Historical Architectural Review Board FINAL Review Sheet

HDC-2024-00022 Address: 213 N Poplar Street District: Old Allentown Historic District Owner: LPR Homes, LLC (Pratik Patel) Applicant: LPR Homes, LLC (Pratik Patel) Proposal: Replace roof

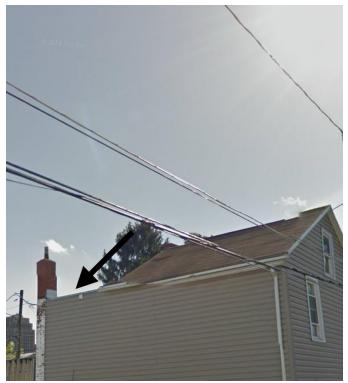
Observations & Comments: The current 3-tab asphalt shingles on the main gable roof are not historic and the proposed replacement material (GAF Timberline HDZ Shingles) are architectural shingles that have an exaggerated taper and overlap; it would be historically appropriate to either replace with 3-tab shingles to match the existing in style or color, or to replace with GAF slateline shingles, which would be more historically appropriate. The flat slope roof is not visible and therefore, the replacement with the SBS roofing is acceptable. The description did not include any work done to the gutters, but if any work is done, it is recommended to use half rounds, as opposed to the k-style that are currently installed.

Discussion: The applicant noted that there are no plans to replace the gutters. The applicant agreed to use a GAF Slateline or similar 3-Tab shingle to match the existing style and color of the current roofing instead of the architectural shingle proposed. No concerns were noted for the flat roofs, as the proposed replacement material was appropriate.

• A 3-tab shingle or a GAF Slateline or similar shingle to match the existing style and color is utilized for the replacement.
